DRIVEABILITY—UNABLE TO REACH WIDE OPEN THROTTLE (WOT)—LACK OF POWER	Article No. 01-18-7

FORD: 2001 RANGER

Figure 1 - Article 01-18-7

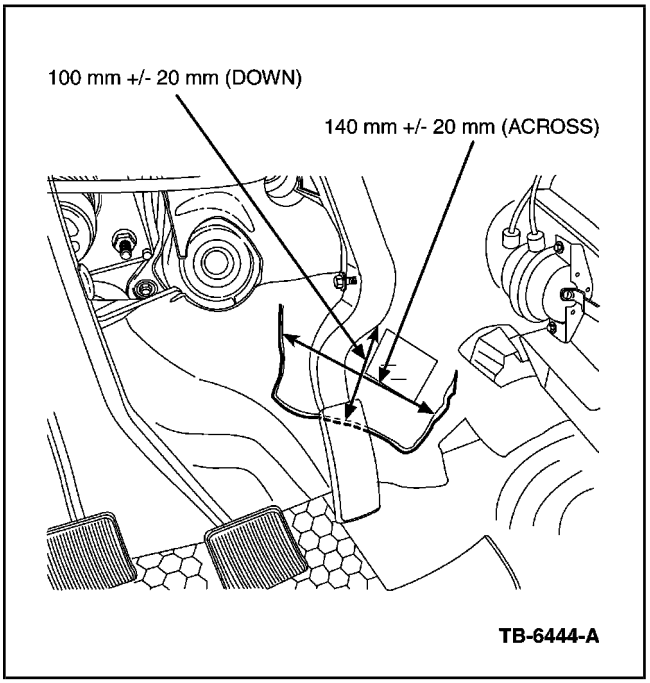
Some Vehicles may exhibit an inability to reach Wide Open Throttle Mode (WOT). This inability to reach WOT can cause a lack of power condition. This may be caused by the Dash Panel Insulator under the carpet at the accelerator pedal.

1. Position carpet to gain access to the area below the throttle pedal.
2. Make a “u-shaped” cut in the insulator below the throttle pedal bracket, 140 mm wide and 100 mm down ± 20 mm (5.5″ wide by 4″ down ± .75 ″), as seen in Figure 1. Make sure to line up the bottom/center of the “U” cut with the throttle pedal bracket, as seen in Figure 2. This will help relieve any tautness in the insulator, so it will sit flush with the floor panel.
3. Reposition the carpet.
4. Using NGS or WDS, verify that WOT mode can be reached without excessive force on the throttle pedal.
